Modification of Minister's Approval

Section 75W of the *Environmental Planning & Assessment Act 1979*

Application Number:	MP10_0076
Proponent:	Sutherland & Associates
The Authority:	Minister for Planning
The Land:	Kirrawee Brick Pit, 566-594 Princes Highway, Kirrawee
Concept Approval:	Kirrawee Brick Pit Concept Plan granted on 23 August 2012 by the Planning Assessment Commission
Project:	Mixed use retail/commercial and residential development and associated public open space
Modification:	<p>MP 10_0076 MOD 3: modification includes:</p> <ul style="list-style-type: none">• 24,265m² increase of GFA (from 60,735m² to 85,000m²), comprising:<ul style="list-style-type: none">• 69,310m² of residential;• 14,190m² of retail/commercial (including 4,740m² supermarket and 1,450m² discount supermarket); and• 1,500m² community facility.• reduction of the total number of building envelopes from nine to seven and reconfiguration and amendment of building envelope locations, footprints, heights, separation distances and setbacks;• amended construction staging and timing of the delivery of the open space; and• removal of the car parking cap and imposition of car parking rates.

The Concept Plan for

- AWNING / ROOF
- PODIUM LEVEL (1 - 4 STOREYS)
- 1 - 8 STOREYS
- 9 - 12 STOREYS
- 13 - 15 STOREYS

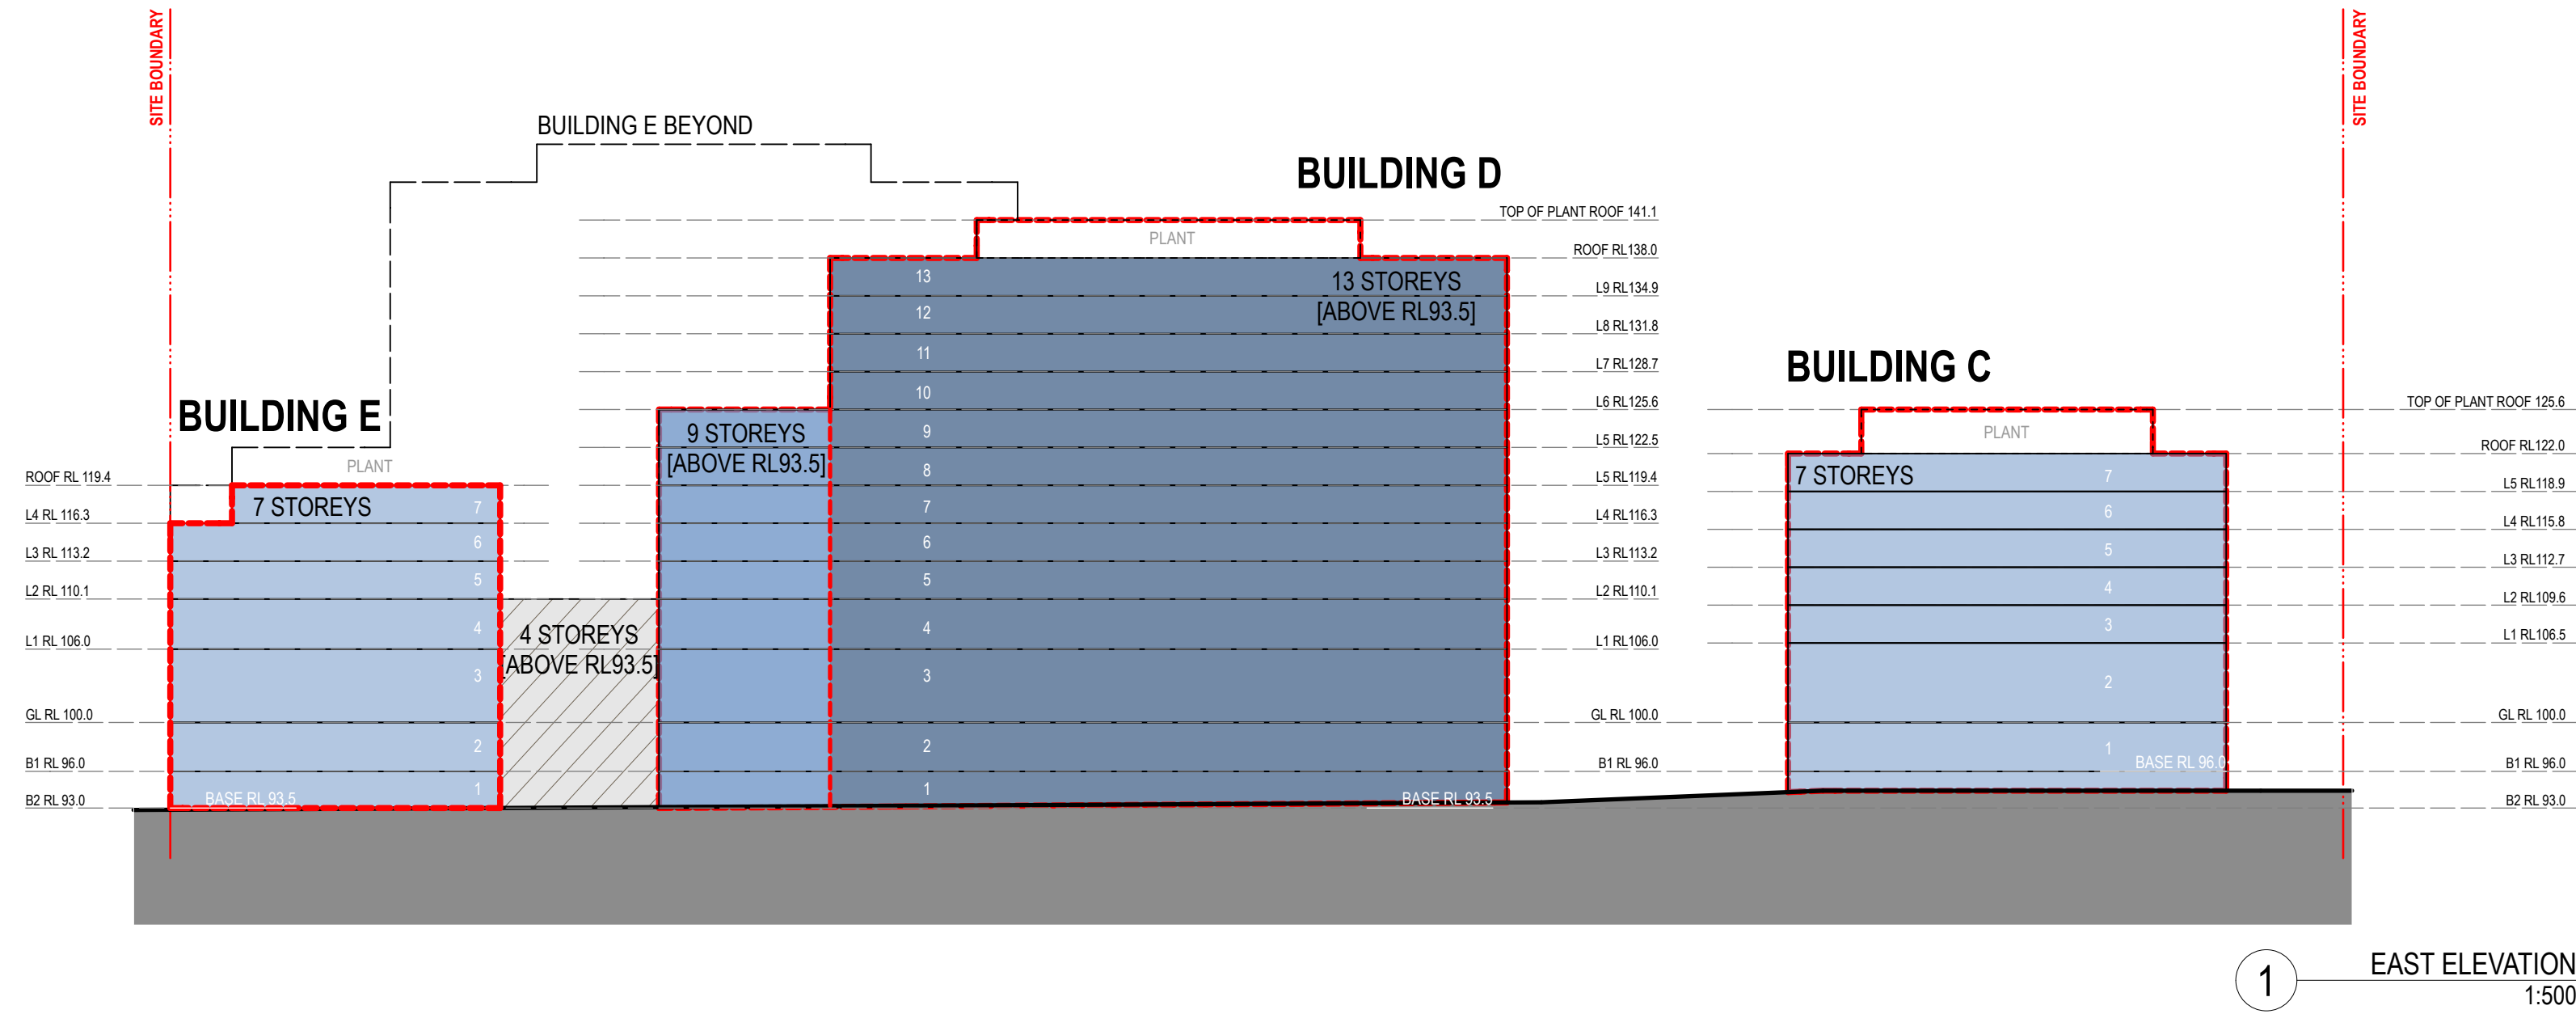
New roadworks and internal roads are to be provided in accordance with the Concept Plan, and associated documents, set out in Drawings ~~0040 & 0130~~ **A-SK-700-001** prepared by **Woodhead Turner Architects**, ~~23 September 2014~~ **19 October 2014** ~~and the Traffic Management and Accessibility Plan prepared by Halcrow Pacific Pty Ltd dated 27 October 2011 (Version 4)~~, and as amended by the Future Assessment Requirements in Schedule 3.

23.09.14 SC		MODG Revised Proposal	
File	Date	Approved by	Revision/Notes
Goals		Project No.	Drawn by North
1:500, 1:1500 @A1, 50% @A3		13040	CH
Status		Dwg No.	Rev
See Information		A-SK-700-005

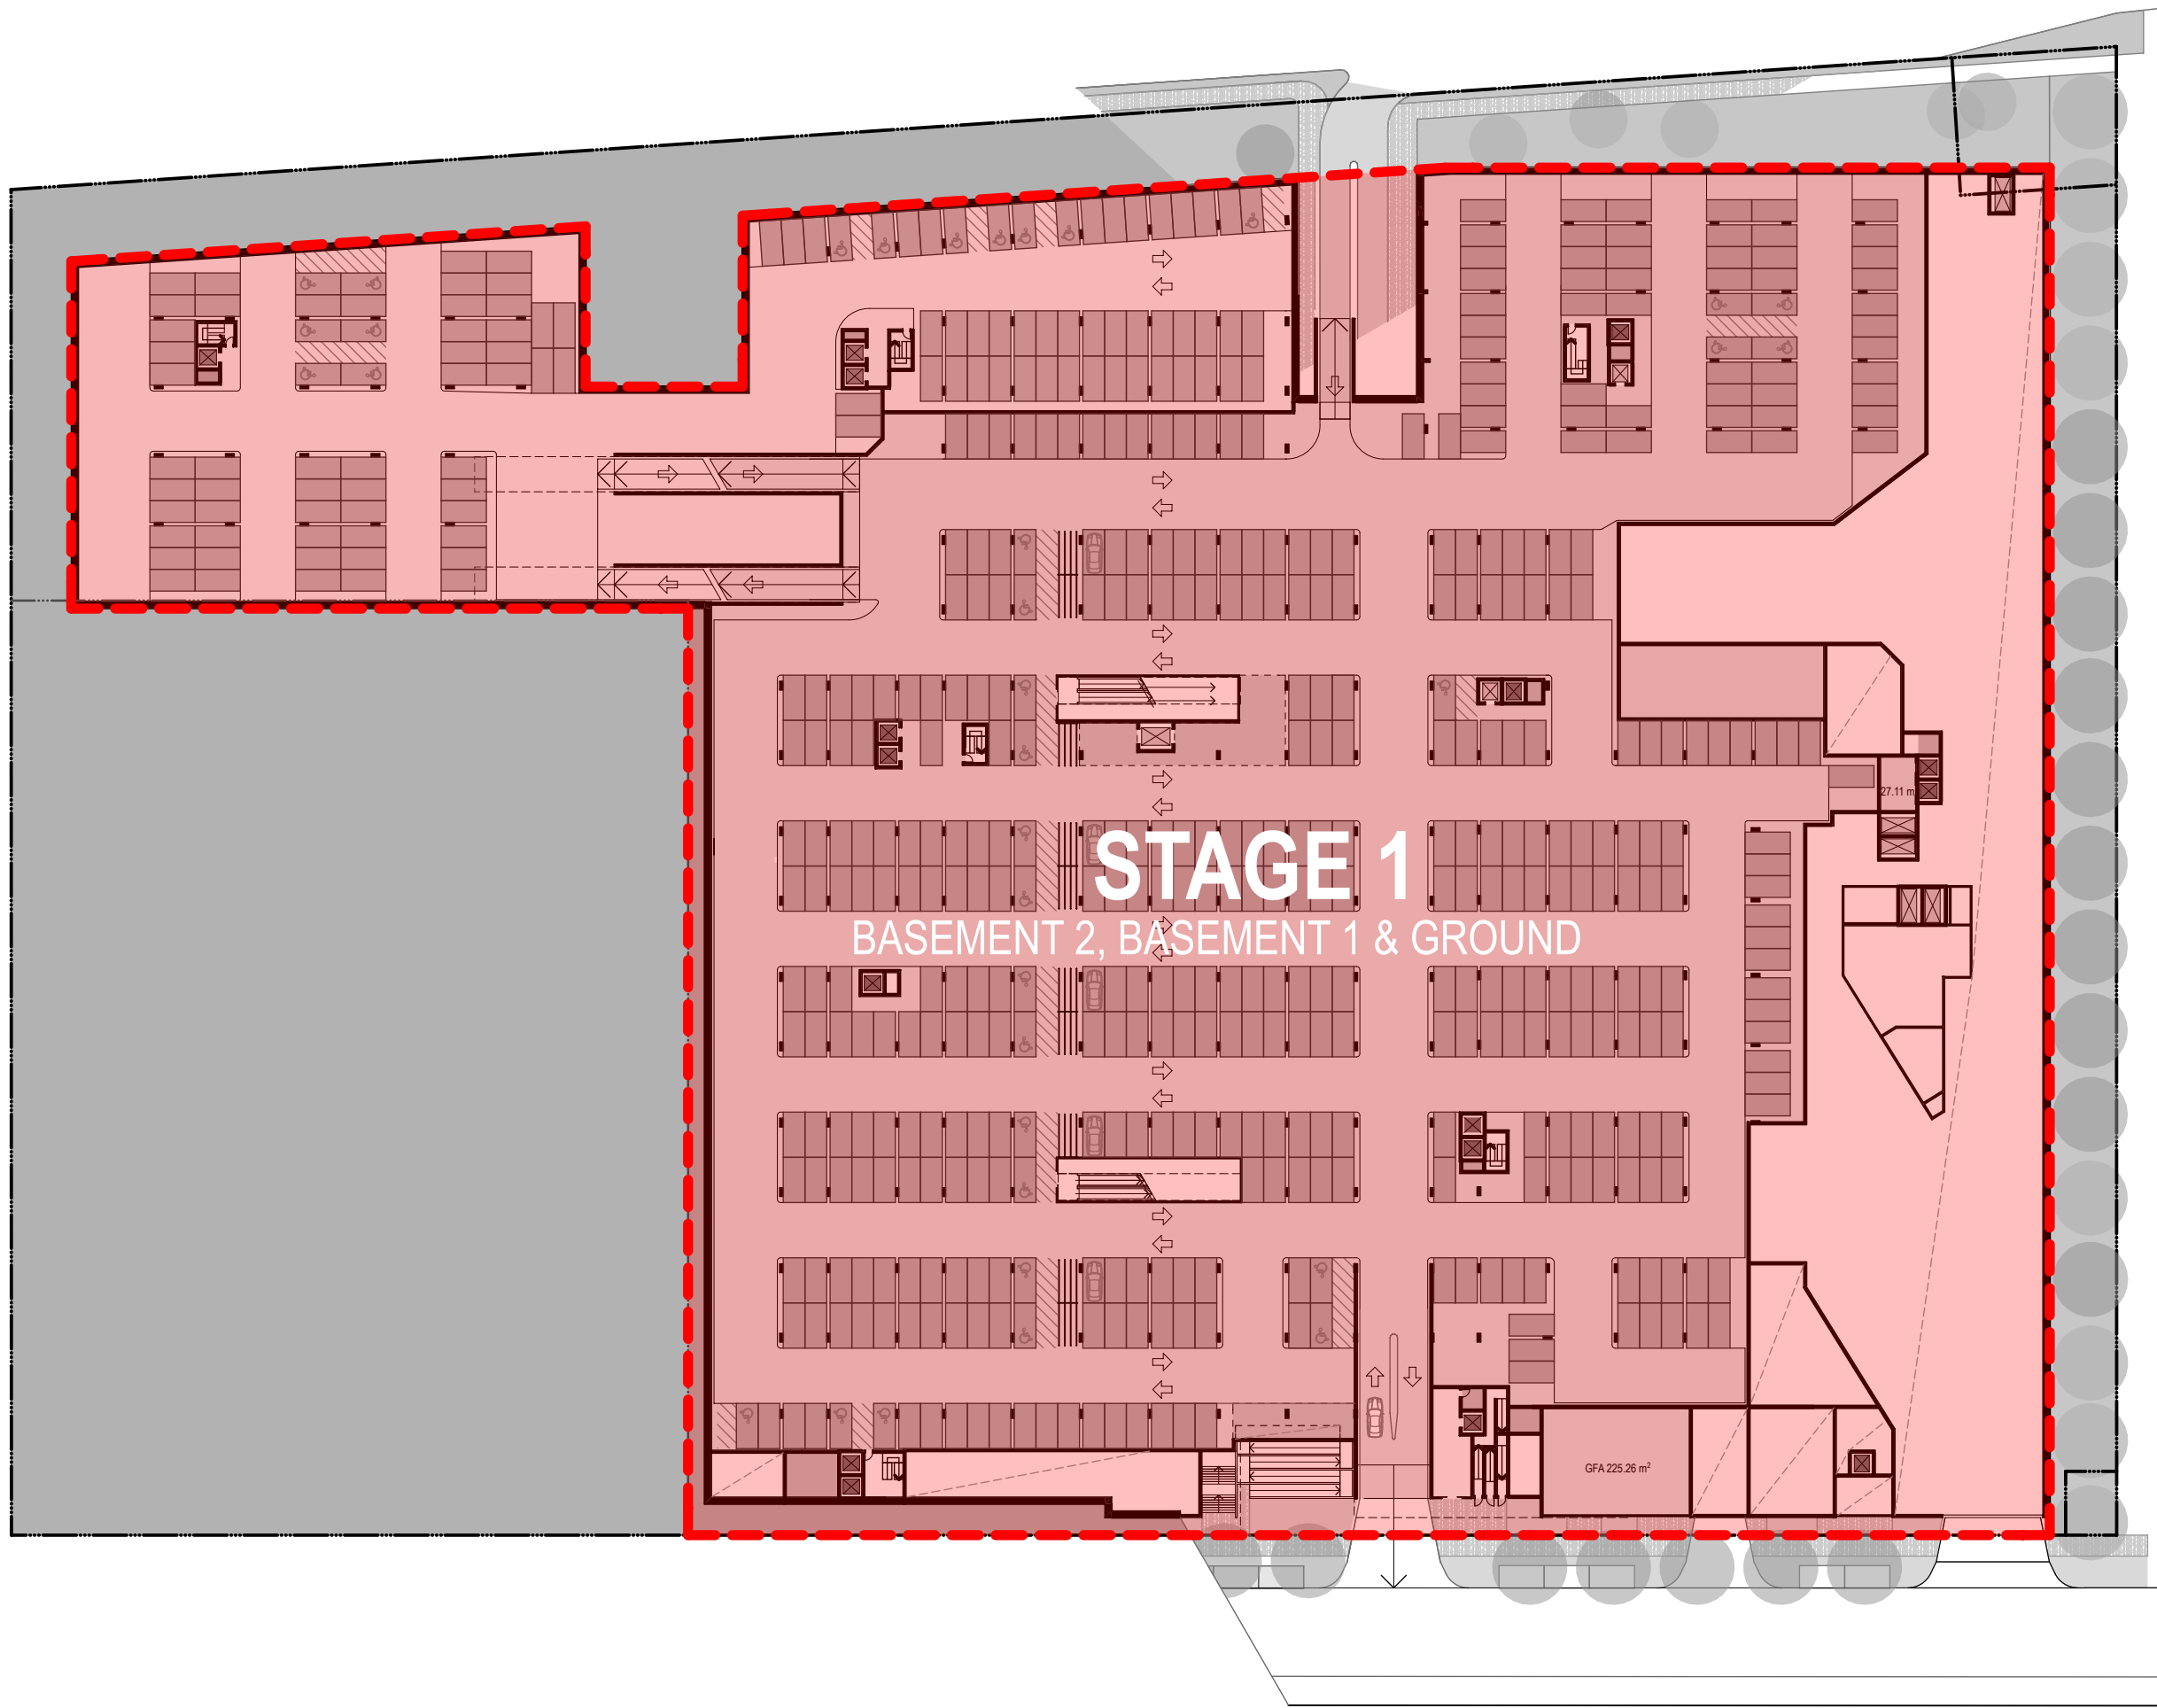
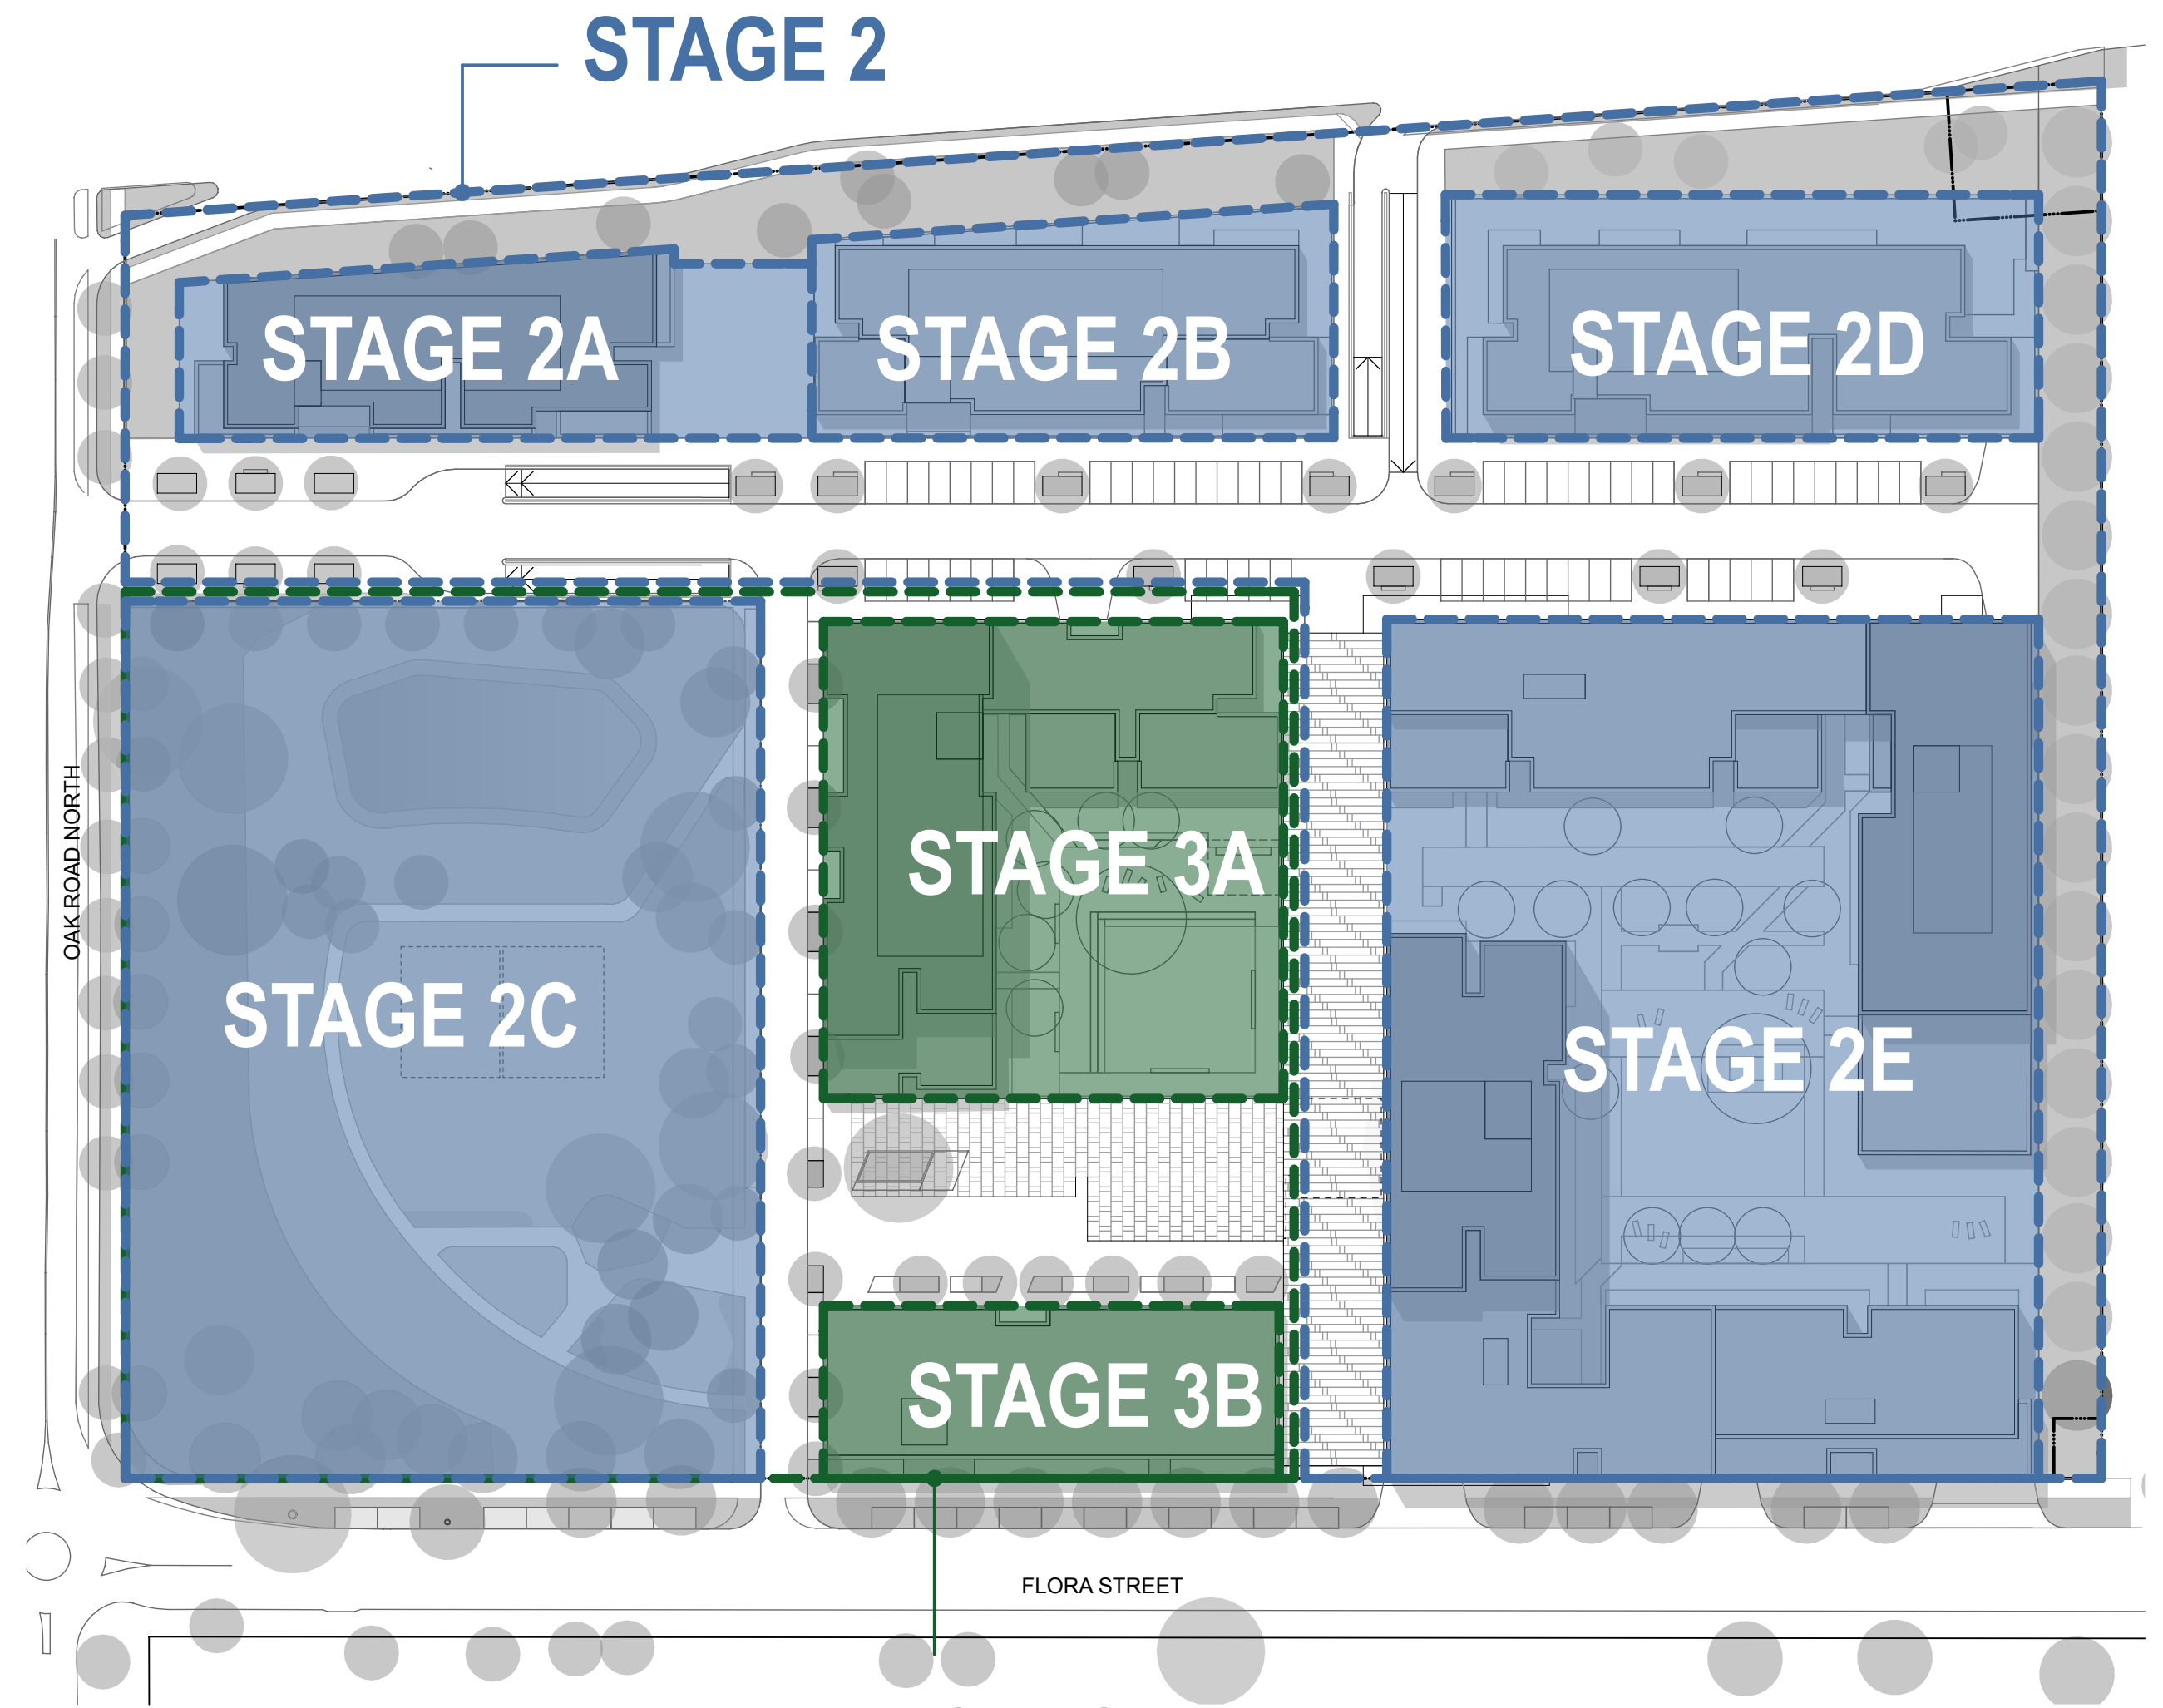
The development application for ~~the first substantive~~ stage **2A** of the development must ~~provide for~~ **include** the design, management and tenure of the public park on the land ~~within Zone 13~~ **shown as 'new park' on drawing A-SK-700-005 listed in Term of Approval A2.**

- a) construction, embellishment and dedication of public open space as shown as 'new park' on drawing A-SK-700-005
- b) construction and dedication of a 1,500m² community facility;
- c) monetary contribution towards the beautification of Kirrawee Shopping Precinct (between Flora Street and Kirrawee Station); and
- d) monetary contribution towards the upgrade of Oak Road (between Flora Street and the Princes Highway).
